Inspection Report for North Sturbridge Road Solar Facility

NPDES ID No.: MAR10031G

Inspection Date: 6/28/2022

**FIGURE 1:
 SWPPP
 INSPECTION
 SKETCH
 6/28/2022**

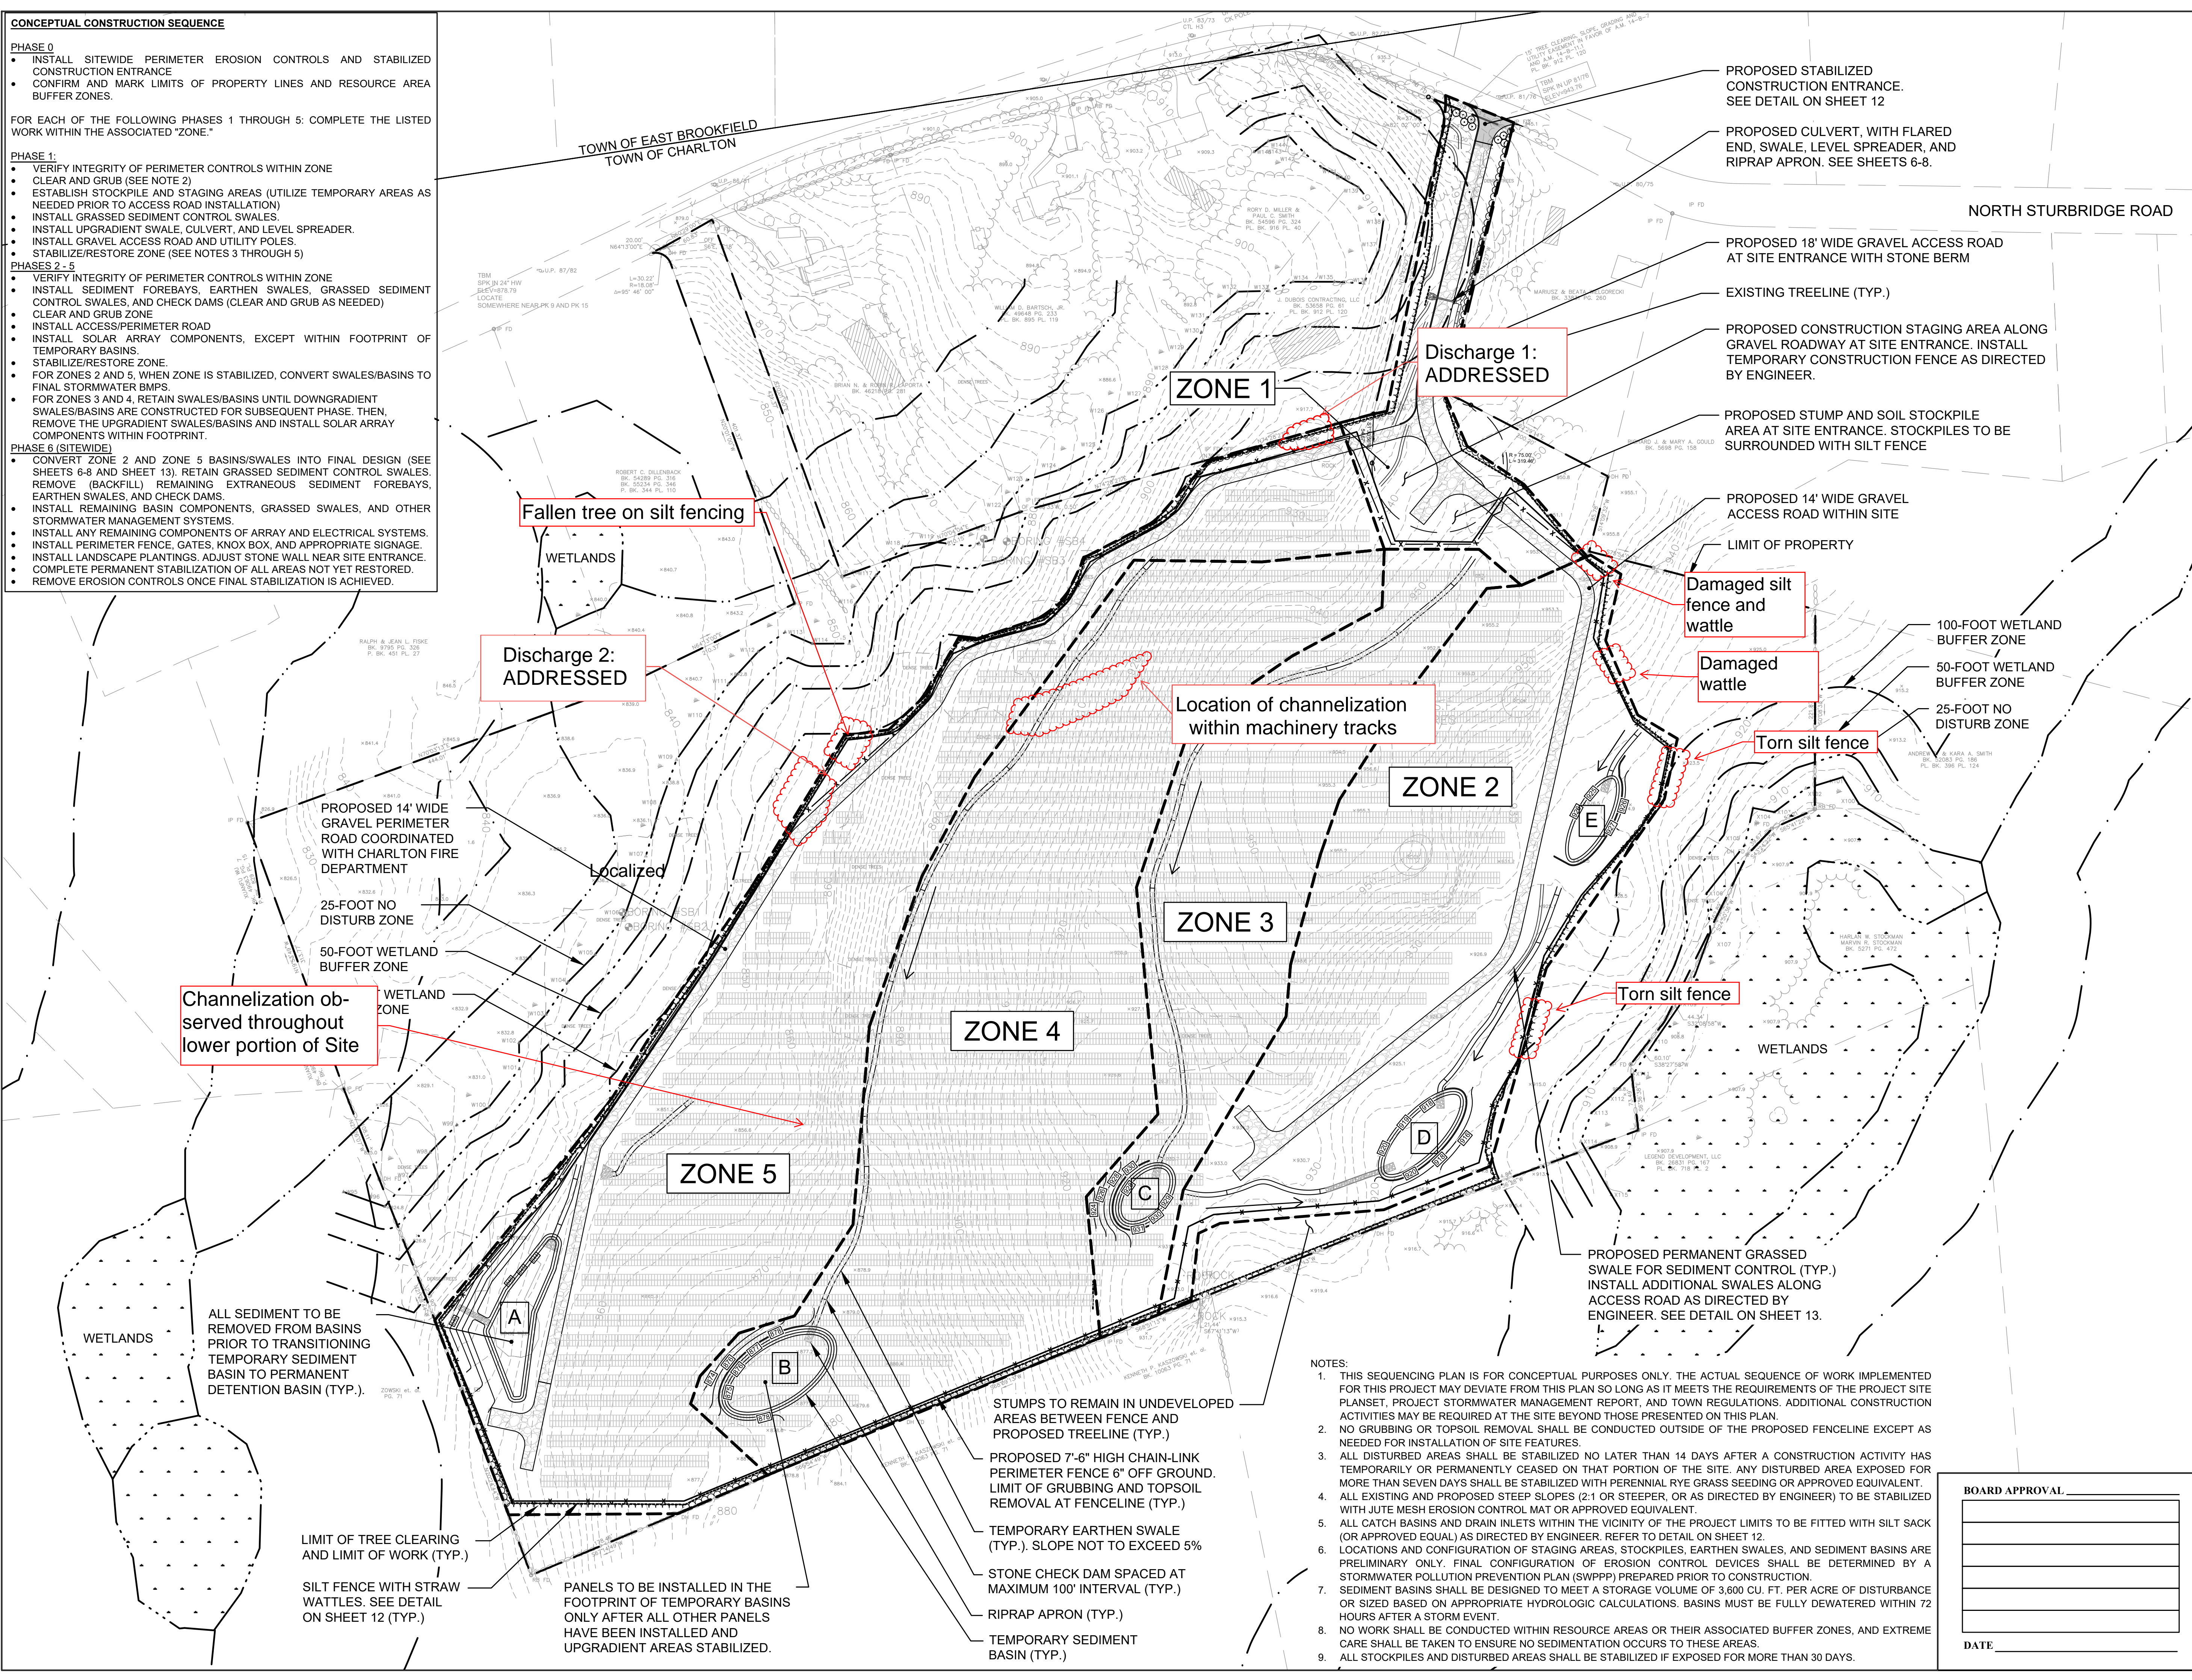
| Type/Location of E&S Control | Maintenance Needed?* | Corrective Action Required?* | Date on Which Maintenance or Corrective Action First Identified? |  |
|---|----------------------|------------------------------|--|---|
| 1. Silt Fence and Straw Wattles | Yes | No | 6/20/2022 | <p>On 6/28/2022 BETA observed fallen tree damage to the silt fence on the western perimeter of the Site, damage was first observed on 6/20/2022</p> <p>On 6/28/2022 BETA observed damage to the wattles in the northeast and eastern corners of the Site, damage was first observed on 3/15/2022. BETA also observed the silt fence to be partly torn in the southeastern corner of the Site, damage was first observed on 3/27/2022. General maintenance is needed for the entire silt fence. No evidence of discharge was observed.</p> |

| Stabilization of Exposed Soil (CGP Part 2.2.14) | | | |
|--|--------------------------|---|--|
| 2. Informal access road along northern portion of the Site | Straw mulch or hydroseed | <input type="checkbox"/> Yes <input checked="" type="checkbox"/> No | Erosion channels are beginning to form within upgradient portions of the informal access road (Figure 1). The contractor indicated that stabilization by smoothing out soils and seeding or spreading mulch would occur on 7/30/2021. Stabilization of this area has not been initiated. After inspection of the area on 8/24/2021, it was determined that |
